10GEPON Jitter Budget

March 2008

Supporting Slides for Comments Submitted to Draft 1.1

Figure 52–4—Mask of the sinusoidal component of jitter tolerance (informative)

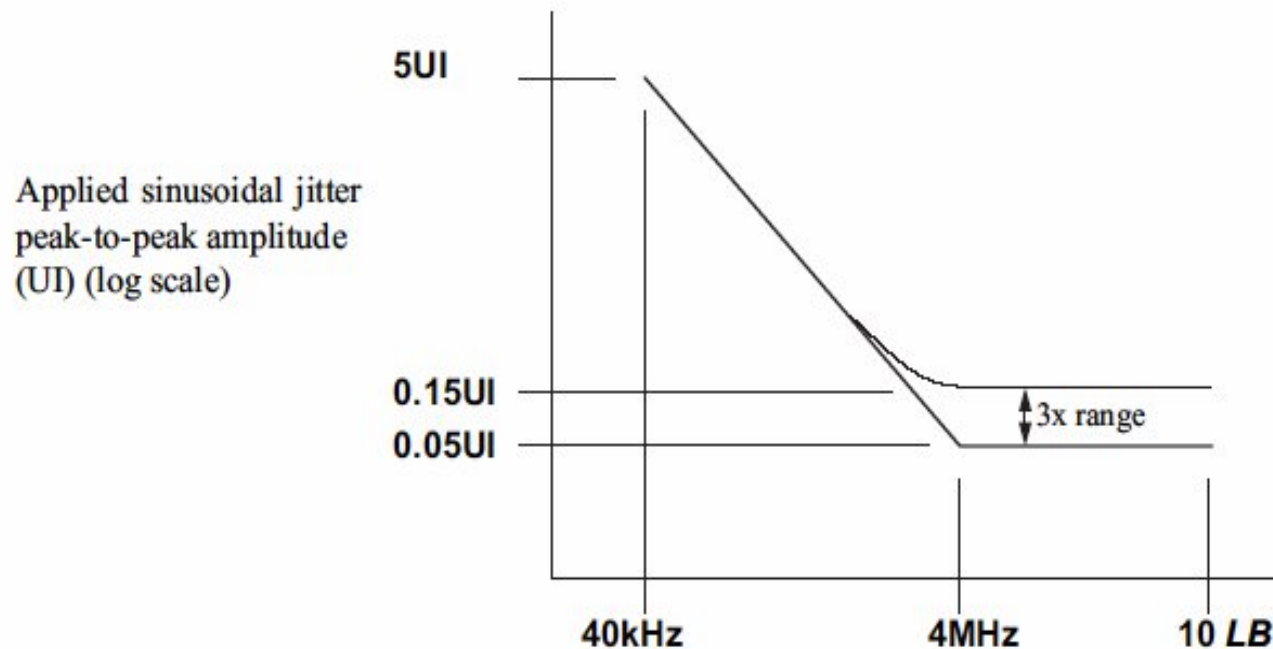
Jitter Corner Frequency

- Comment: #1047 and #1053

Figure 60–5—Jitter gain curve values for 1000BASE-PX10-U and 1000BASE-PX20-U

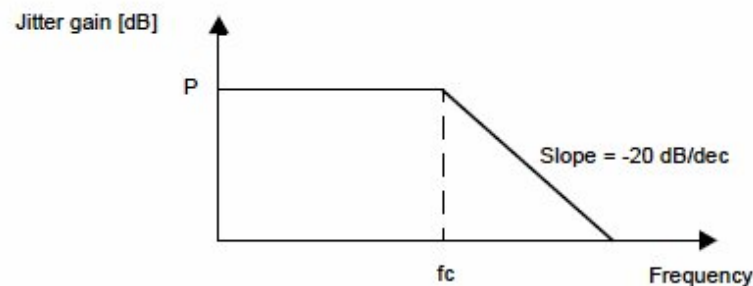
Jitter gain curve (Jitter transfer)

- Jitter transfer corner frequency was chosen to be double of jitter corner frequency of receiver
 - RX: 637 kHz > Transfer: 1274 KHz
 - RX: 4MHz > Transfer: 8MHz
